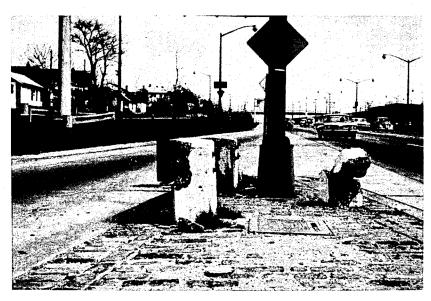
Here is a view of light posts. Here you have an easy-knockdown light pole and concrete stanchions protecting it. They have been hit.

This is what I asked the Office of Highway Safety to clear. I asked them to get a project going to taper this curb off. This is a killer. You could be riding along, 60 miles an hour, and if you have a tapered curb you would get a second chance. But once you hit this, it causes unnecessary damage, and maybe three or four cars are involved. If this curb is tapered, and we would clear all this junk in that gore, it would be much safer.
